Application for Works Approval

Works Approval Number	W6801/2023/1
Applicant	Puma Energy (Australia) Kwinana Pty Ltd
ACN	167 227 858
File number	DER2023/000273
Premises	Puma Energy – Kwinana Fuel Terminal Lot 9002 Kwinana Beach Road KWINANA WA 6167 Legal description – Part of Lot 108 on Plan 400167
Date of report	28 July 2023
Decision	Works approval granted

Figure 1 Premises overview identifying new Uploading facility and Tanks

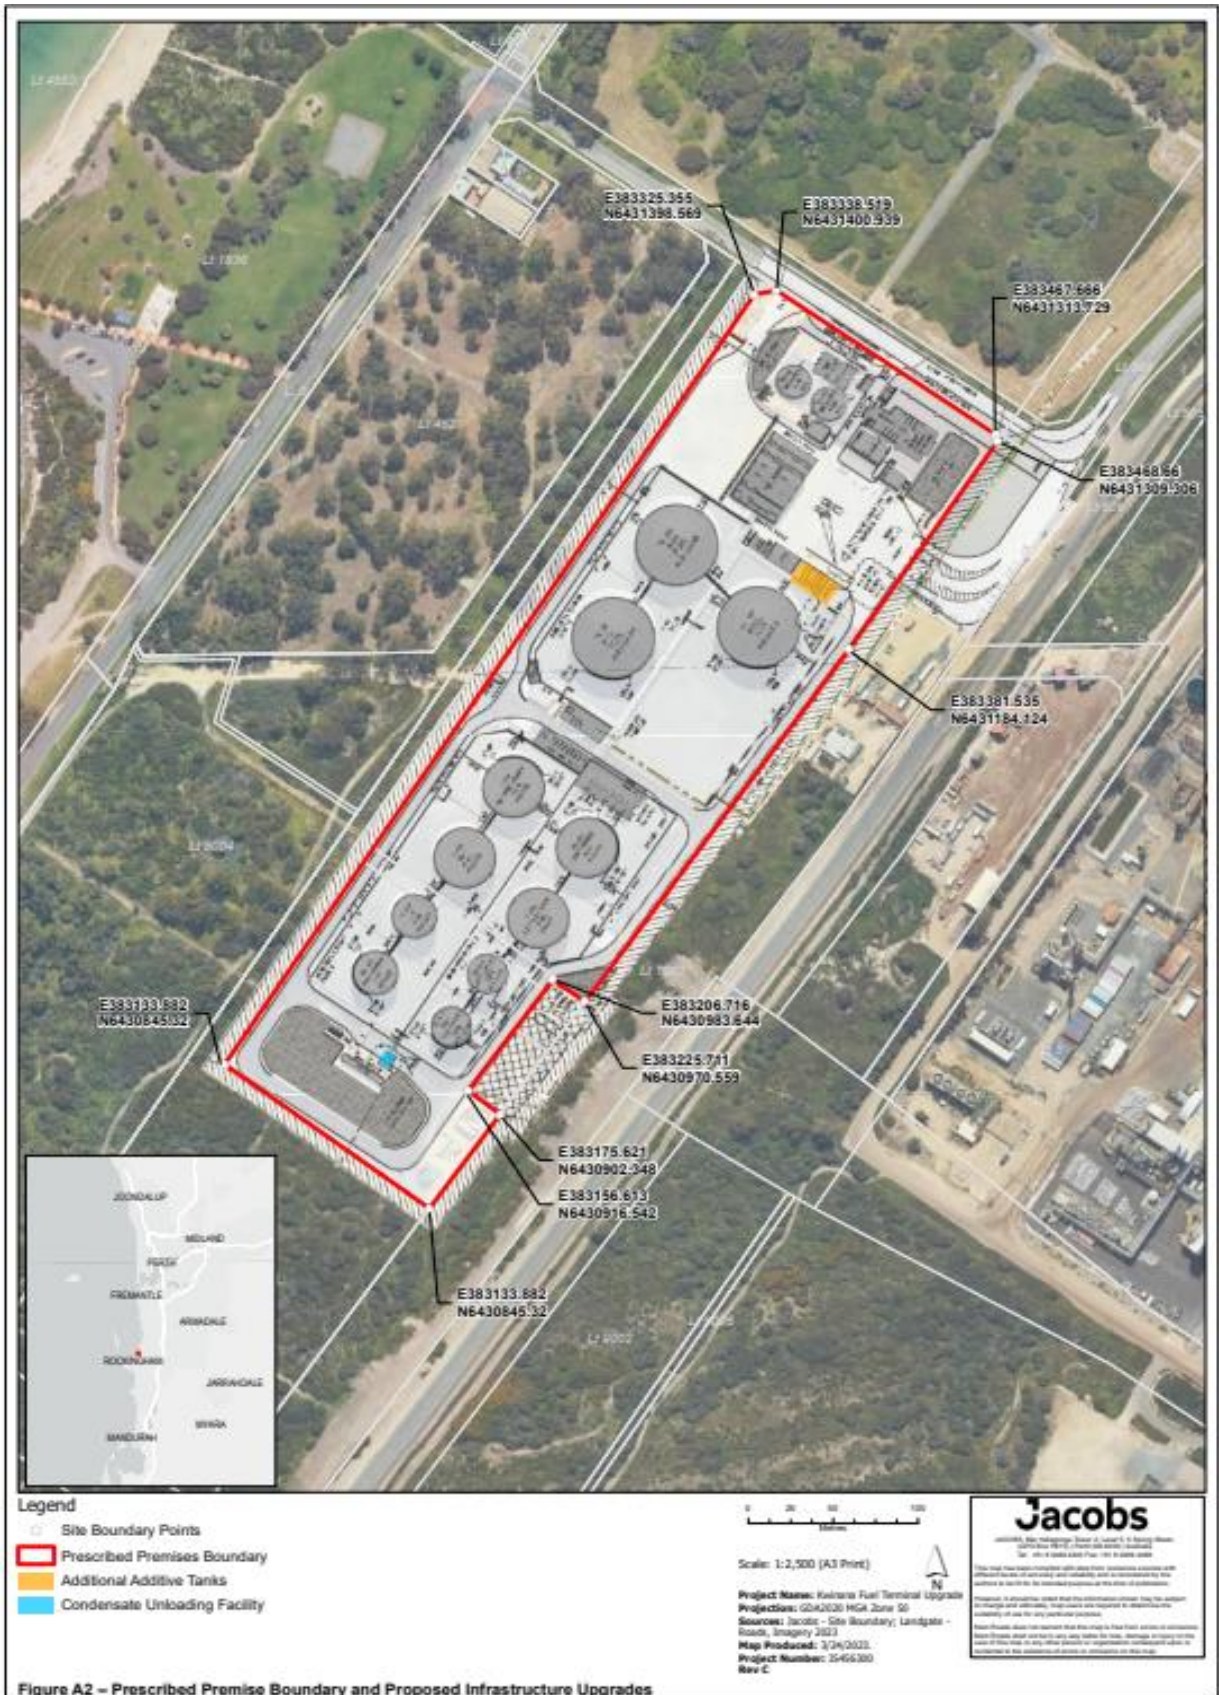
Stakeholder	Summary of applicant's comment	Department's response
City of Kwinana 21/06/2023	<p>Thank you for the above invitation to comment for Puma Energy.</p> <p>The supporting information with maps has a variation between the existing layout and the proposed layout at the front of this site. Please confirm with the applicant and ensure the correct layout is shown, incorporating the stormwater basin and treatment units.</p>	<p>Noted.</p> <p>The City of Kwinana comment on the variation of the existing and proposed layout will be presented to the Applicant for comment prior to Approval of the Works Approval.</p> <p>The Applicant advised on 26 July 2023 that Puma confirms that the correct site layout is shown on Figure A2 of Appendix C of the Supporting Information Document and in Appendix D (Site Layout) of the Supporting Information Document. The correct layout is also shown in Schedule 1 of the Draft Works Approval.</p> <p>It is noted that the Noise Assessment provided as Appendix F of the Supporting Information Document included an older (now incorrect) version of the site layout and it is assumed that this is the 'proposed layout' that City of Kwinana is referring to.</p>
